of Iransportation Federal Highway Administration JIN I O 1022

Geometric and Roadside Design Acceptance Letter Number LS-26

Geometric and Roadside Design Acceptance Letter LS-26A

Supplemental to Geometric and Roadside Design Acceptance Letter LS-26B

Figure 2. Manufacturer's Drawing of Test Article

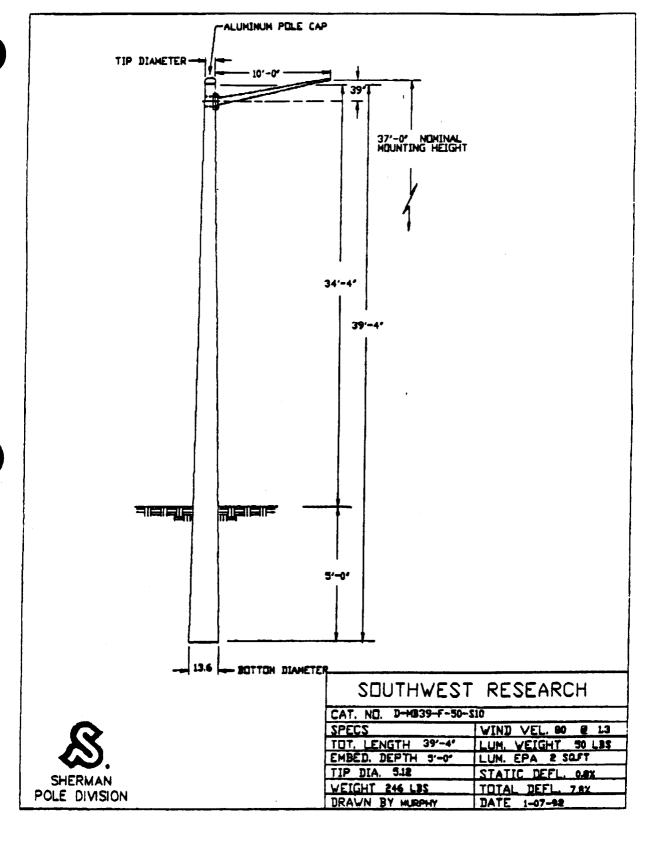
One test was conducted to assess the compliance of the Sherman Catalog Number D-MB39-F-50-S10 direct burial fiberglass luminaire support with the breakaway requirements of the 1985 AASHTO Standard Specifications for Structural Supports for Highway Signs, Luminaires and Traffic Signals. These specifications have been adopted, with minor modifications, by the FHWA. The test article is described in the enclosed specifications and drawing, and is considered representative of the largest of the breakaway direct burial poles.

The new breakaway design is achieved by weakening various layers of the fiberglass mats as well as adding a bondbreaker between the layers during fabrication of the pole. The pole is also strengthened above and below the impact zone with additional glass reinforcement. This breakaway design will supersede Sherman's previous direct burial fiberglass poles which received FHWA acceptance via our letter of November 10, 1988. We understand the special designation "85BK" will be given to your company's new line of breakaway poles so that they may be easily differentiated from non-breakaway models.

Luminaire Mounting Height, m (ft.)	11.28 (37.0)
Mass of Pole, Mast Arm, and Luminaire <u>above</u> point of breakaway, kg (lbs.)	<b>106. 8</b> (235. 0)**
Pendulum Mass, kg (lbs.)	818 (1,800)
Inpact Speed, km′h (mph)	32. 2 (20. 0)
Velocity Change, m⁄s (fps)	2.04 (6.69)
Calculated High Speed Velocity Change, m⁄s (fps)	1.75 (5.73)
Stub Height mm (in.)	<b>250</b> (9.8)***

These results meet the change in velocity and stub height requirements adopted by AASHTO and the FHWA. Therefore, your company's fiberglass pole described above is acceptable for use on Federal-aid highway projects, within the range of conditions tested, if proposed by a State. You also asked for our acceptance of several other poles which would be expected to perform at least equal to the tested pole with respect to vehicular inpact. A listing of the catalog numbers and sizes of these poles are enclosed. We concur that these additional poles are also acceptable for use on Federal-aid highway projects as discussed above.

Figure 2. Manufacturer's Drawing of Test Article

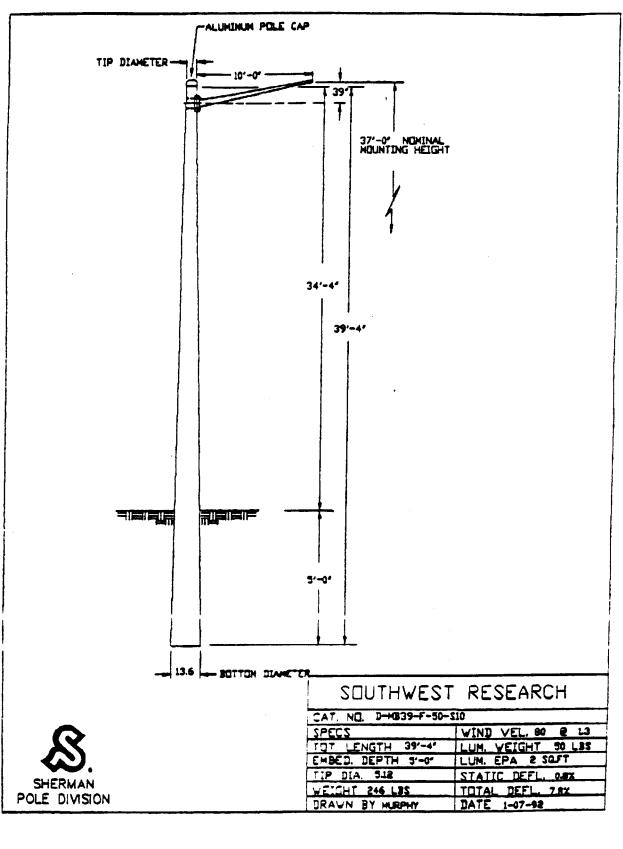
Perfect sheaf of the pole upon impact was achieved through introducing the following modifications to the conventional pole design.

- 1. Cutting each glass laminate in the vicinity of the groundline. However not all glass layers are cut at the same section. Cuts are staggered approximately 4 inches apart.
- 2. Placing a layer of polyethylene foil (approx. 40" wide x 17" long) between the glass layers in me vicinity of the impact zone. The foil has holes cut in approximately 50% of its area to allow the passage of the resin during spinning of the pole. The objective of me polyethylene foil is to delaminate the pole in the impact zone, thus decreasing its shearing and flexural resistances considerably in that zone.
- 3. Providing additional glass reinforcement above and below the impact zone. This aids in confining the impact effect to the weakened zone and prevents failure from spreading to other regions of the pole.

The following additional poles are acceptable for use on the NHS, if requested by a State.

All conditions in our June 10, 1992, letter remain in effect.
